Re: Seven Clover
3641 12th St NW
Site Plan
Architect's Stamp 8-27-23 (G14D062)

Based upon the information provided in your submittal received 12-4-23, the above referenced plan cannot be approved for Building Permit until the following comments are addressed:

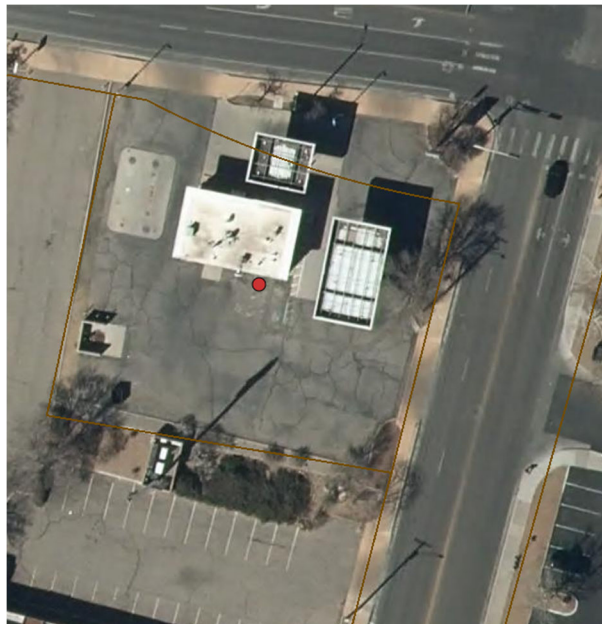
1. Complete the Traffic Scoping Form and send to Matt Grush.
2. The BernCo Assessor database shows an interesting property line (Brown line) along the northern boundary. See below:

Please confirm this is the correct property line or provide information (e.g. plat) that shows a different property line.
